Intel[®] StrongARM^{*} SA-1111 Microprocessor Companion Chip

Specification Update

March 2000

Order Number: 278260-008

Figure 2-1. SA-1111 Block Diagram

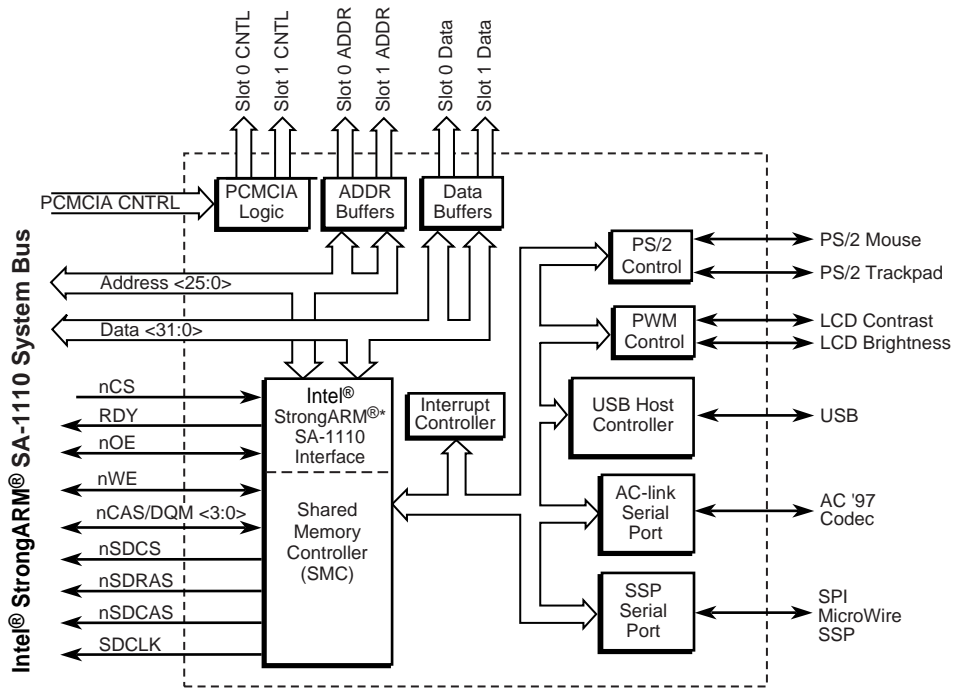
1. Functional Blocks: Section 2.1

Changed the signal nOE in Figure 2-1 from an input to a bi-directional arrow. Figure 2-1 now appears as follows:

Figure 3-7. SDRAM Read Cycle, Burst of 2 - CAS Latency = 3

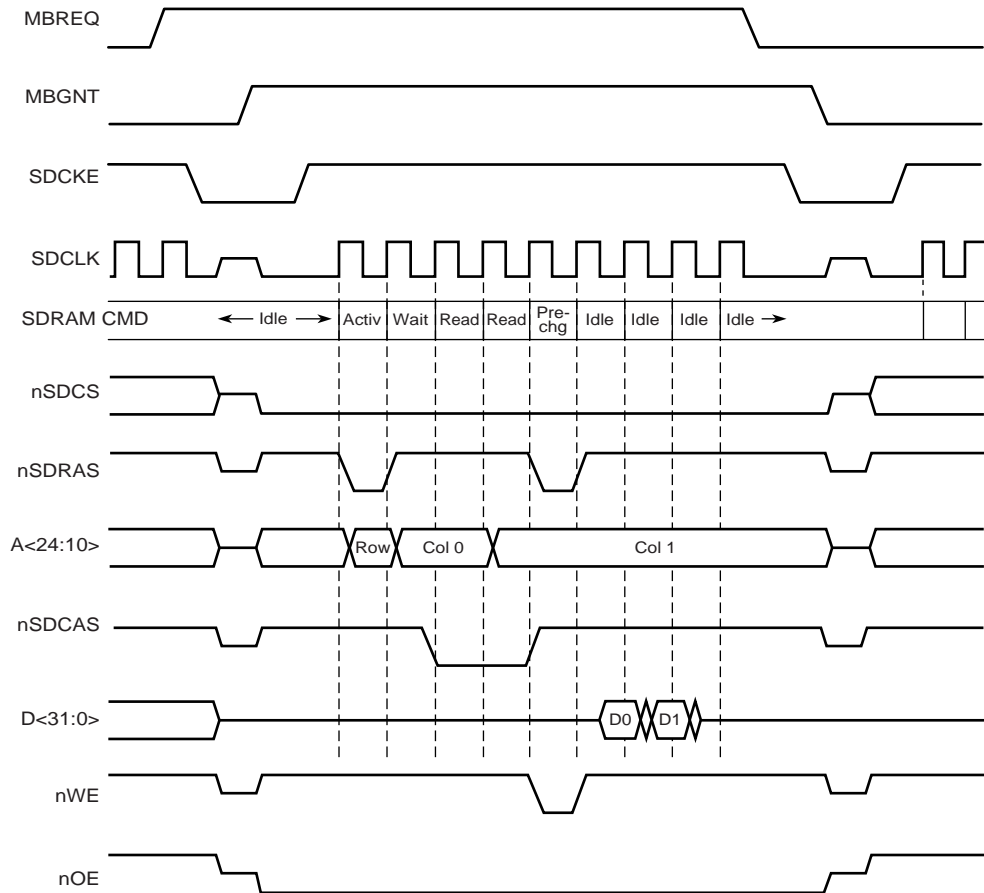
3. DRAM Control Signal Generation: Section 3.2.3.5

Signal nOE added to bulleted list, added text to this section, updated Figure 3-7 and Figure 3-8. This section now appears as follows:

The SMC also drives signal nOE during DMA transfers. The behavior of nOE is programmable for use in systems with different bus architectures. The nOE behavior may be enabled or disabled. For example, a design may limit system bus loading by placing buffers and transceivers between the SA-1110 (with its system memory) and other peripherals, including the SA-1111. For DMA cycles, the SA-1111 must move data through the transceivers in either direction, depending on whether it is a read or write transfer. Signal nOE may be used to control transceiver direction if it is enabled. When enabled, it is asserted low on reads to SDRAM, and remains high for writes.

Other systems may not require nOE assertion for DMA transfers. If it is disabled, nOE is still driven by the SA-1111 but remains high (deasserted) for both reads and writes.

Figure 4-1. Decoder Block Diagram

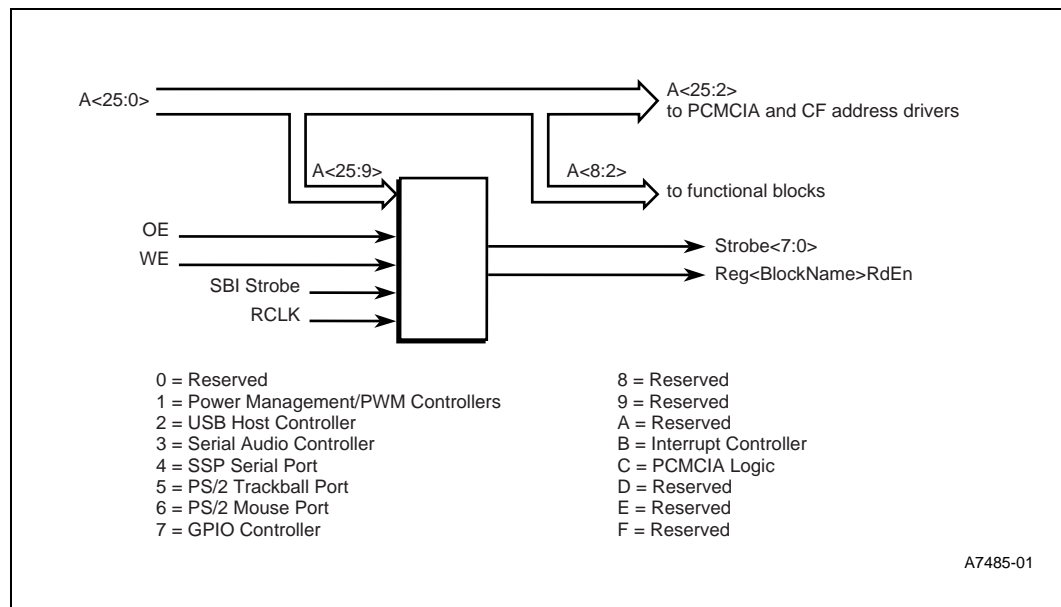
6. RAB Central Address Decoder: Section 4.1.1.

Updated address assignments in Figure 4-1. Figure 4-1 now appears as follows:

Figure 7-4. MSB-Justified Data Formats (16 bits):

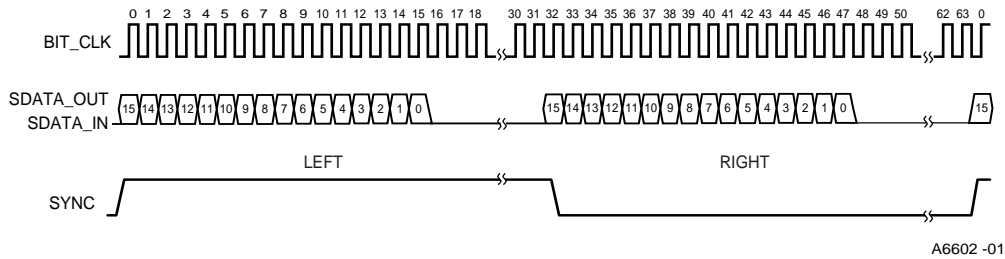
11. I²S and MSB-Justified Serial Audio Formats: Section 7.3.2.2

Update Figure 7-4 MSB-Justified Data Formats (16-bits). Figure 7-4 now appears as follows:
